**RE: Expedited Settlement Agreement, Number: ES-110713-1  
CDPS Permit No: COR-03E512**

## EXPEDITED SETTLEMENT AGREEMENT

RE: Facility Inspection/**Compliance Advisory**  
Alma Super Storage  
CDPS Permit No. COR-03E512  
Park County

## Stormwater Inspection Report

Photo 1: Land disturbance along the east side of the project boundary. Rill erosion is evident throughout the slope disturbance. The stormwater drains to the north and into the retention pond.

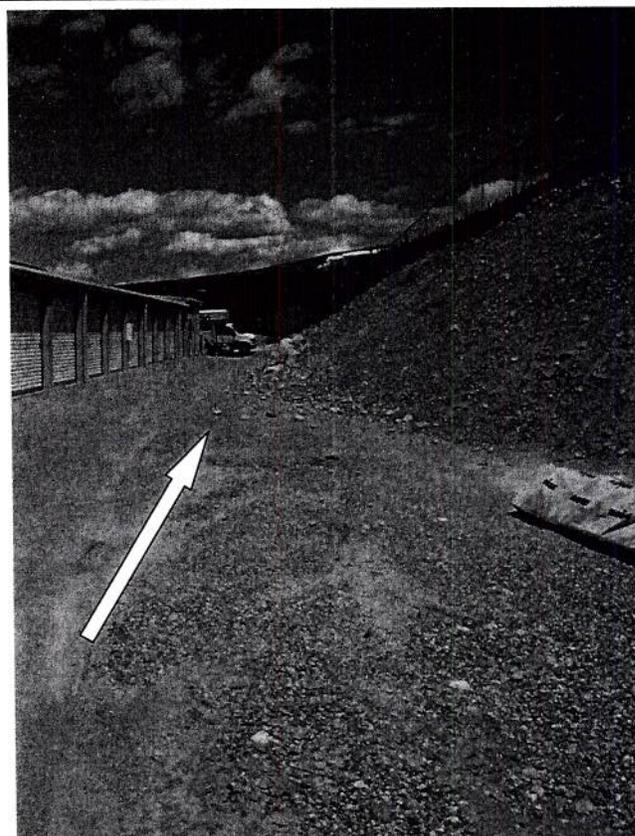
4. It was noted during the inspection that inadequate BMPs were implemented to manage stormwater runoff from the areas of disturbance along the eastern side of the project boundary (photo 1 and 2), the stockpiles of soil located near the south eastern section of the construction site (photo 3 and 4), and areas of disturbance along the north, north-eastern side of the project boundary (photo 5). Erosion rills were observed along the eastern disturbed slope (photo 1). Stormwater runoff from the disturbed areas identified above all drains to the north and discharges through a culvert to a retention pond. Straw wattles were installed down gradient of this drainage area in front of the culvert that drains to a retention pond (photo 5). The SWMP did not identify installation and implementation specifications for the straw wattles. The straw wattles were not installed following good engineering, hydrologic and pollution control practices. According to good engineering, hydrologic and pollution control practices, straw wattles must be trenched in the ground and staked through the wattle in order to create a seal with the ground to prevent undercutting. The installed straw wattles were not trenched nor were they staked through the wattle (photos 5 and 6). All BMPs must be implemented according to installation and implementation specifications outlined in the SWMP. All installation and implementation specifications outlined in the SWMP must follow good engineering, hydrologic and pollution control practices. In addition, the straw wattles were not inspected and maintained in good and effective operating condition. The portion of the straw wattle located west of the culvert was ripped (photo 6). All BMPs must be inspected and maintained in good and effective operating condition.

Photo 8: Erosion straw wattles along the western side of the construction boundary are not installed correctly as there are gaps between the wattles and the wattles are not properly staked.

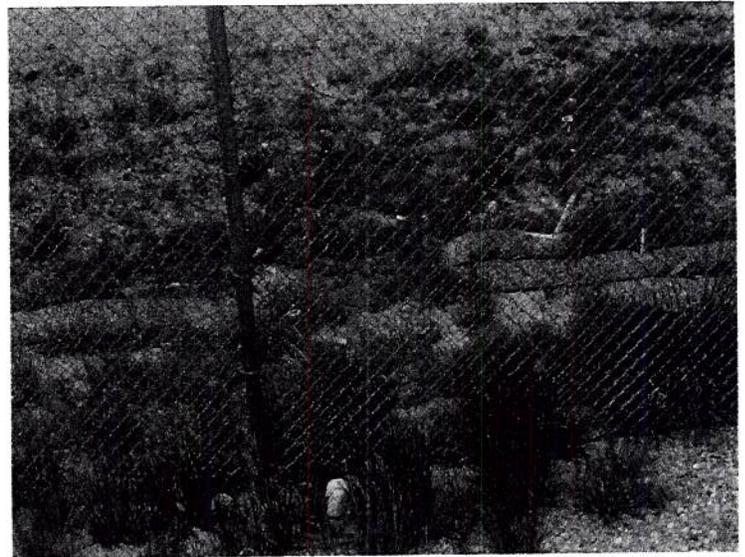
6. It was noted during the inspection that inadequate BMPs were implemented to manage stormwater runoff from the disturbance along the west side of construction boundary. Stormwater runoff from this disturbed area drains to the northwest to a roadside drainage ditch. A series of erosion straw wattles were installed along the western boundary to manage the stormwater runoff from the disturbed area identified above. The straw wattles were not installed according to good engineering, hydrologic, and pollution control practices. The straw wattles were not properly abutted as there were gaps between where one wattle ends and another wattle begins (photo 8). In addition, the straw wattles were not installed on the drainage contour and were not properly staked (photo 9). As a result, there was evidence of a discharge of sediment beyond the straw wattles and deposited offsite into the roadside ditch located west of the construction site boundary, adjacent to Highway 9 (photo 15). The roadside ditch discharges to the Middle Fork South Platte River located approximately 600 feet to the south. All BMPs must be implemented according to installation and implementation specifications outlined in the SWMP. All installation and implementation specifications outlined in the SWMP must follow good engineering, hydrologic and pollution control practices.

Photo 10: Failure to implement BMPs to manage stormwater runoff from the drivable surfaces at the entrance and along the west side of the construction site.

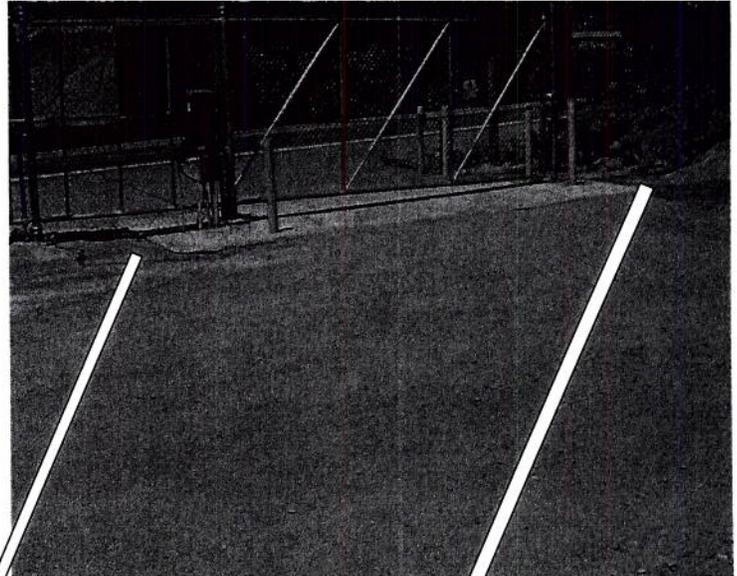
7. It was noted during the inspection that BMPs were not implemented to manage the stormwater runoff from the drivable surfaces located on the west side of the constructed storage facilities, including the entrance. The drivable surfaces were constructed out of a loose road base material that was highly erodible. The road base was comprised of loose dirt, fines, and some aggregate. Stormwater runoff from these drivable surfaces drains to the west and to the northwest side of the construction site boundary, to a roadside drainage ditch. There was evidence of erosion occurring on the drivable surface located at the southeast and northeast side of the entrance gate (photos 10, 11 and 12). As a result, there was a discharge of sediment into the roadside ditch identified in Finding 6 (photo 15). BMPs must be implemented to manage stormwater runoff from all potential pollutant sources. All BMPs must be implemented according to installation and implementation specifications outlined in the SWMP.

Photo 15: Sediment in the roadside drainage ditch located east of Highway 9 and west of construction site. Ditch ultimately flows to the North Fork of S. Platte River approximately 600 feet to the south.

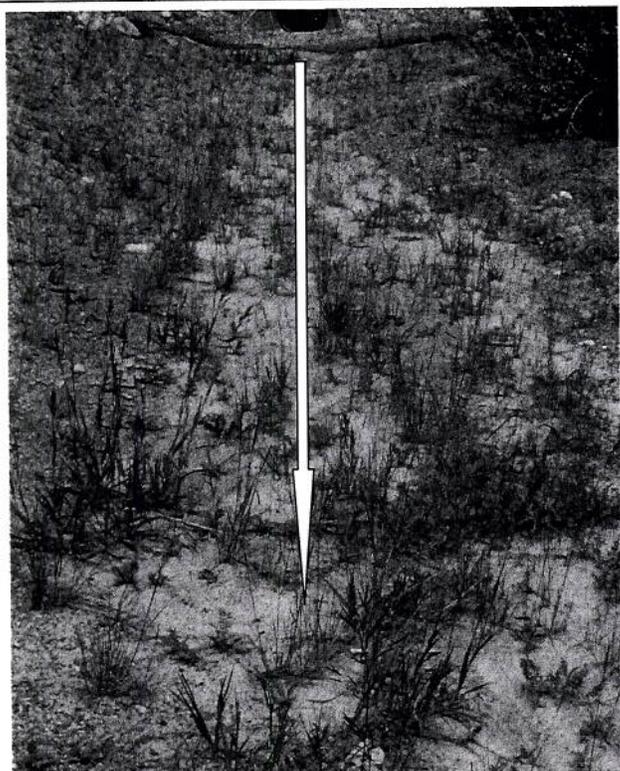
8. It was noted during the inspection that BMPs were not implemented to manage stormwater runoff from the disturbed slope located on the northwest side the construction site, north of the entrance (photos 13 and 14). There was evidence of erosion and a discharge of sediment from the disturbed slope into the roadside drainage ditch identified in Finding 6 (photos 14 and 15). BMPs must be implemented to manage stormwater runoff from all potential pollutant sources. All BMPs must be implemented according to installation and implementation specifications outlined in the SWMP.
